# Expert Witness

## Greenhouse Gas Emissions

Presentation to the Inquiry and Advisory  
Committee Hearing

Crib Point Gas Jetty and Crib Point-Pakenham  
Pipeline Project Environmental Effects Statement

# Upstream emissions from various LNG sources

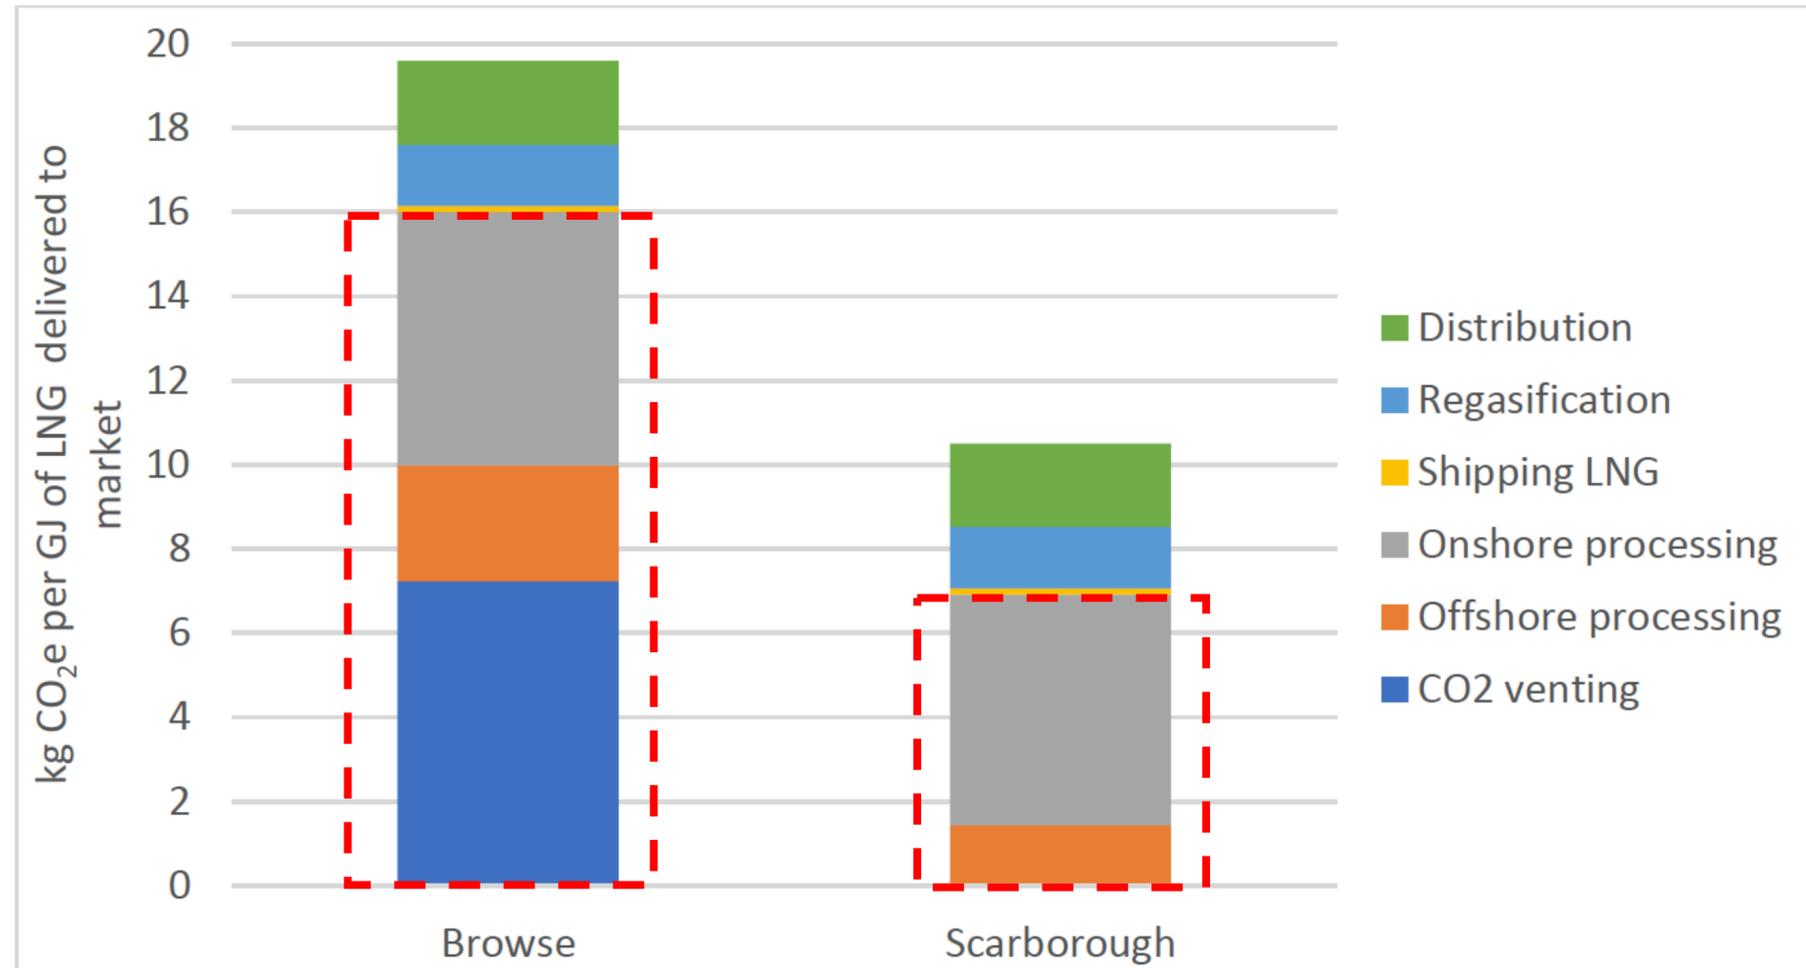
Qatargas = 8.2646 kg CO<sub>2</sub>-e/GJ for extraction and liquefaction.

Browse and Scarborough are gas fields in Western Australia

## EES Greenhouse Gas Inventory Review

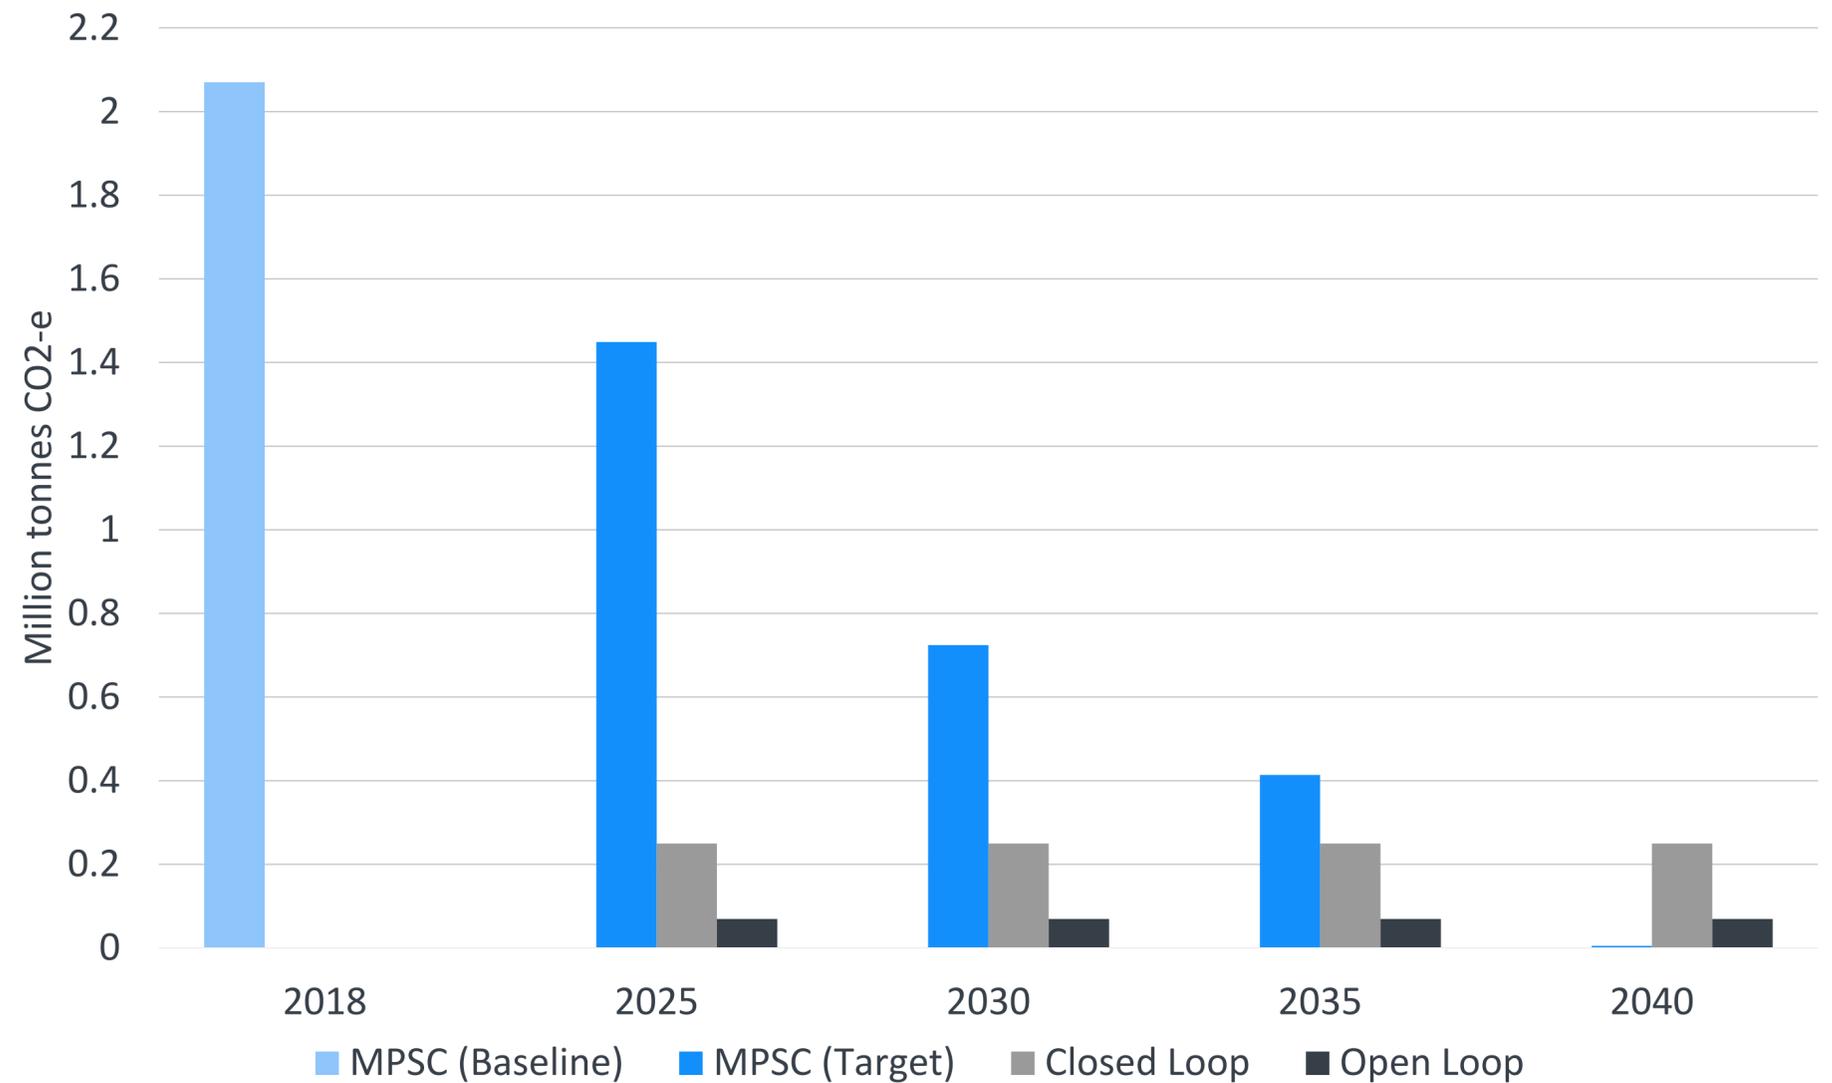
Calculations covering construction and operational emissions utilise a reasonable estimation methodology that follows industry standards.

The base assumptions used in the calculations pertaining to equipment selection cannot be fully verified.

# The use of offsets has not been adequately addressed.

Mornington Peninsula Shire Council (MPSC) has a community reduction target of net zero emissions by 2040. This project will have a significant impact on the ability to meet this target over time without the use of offsets.
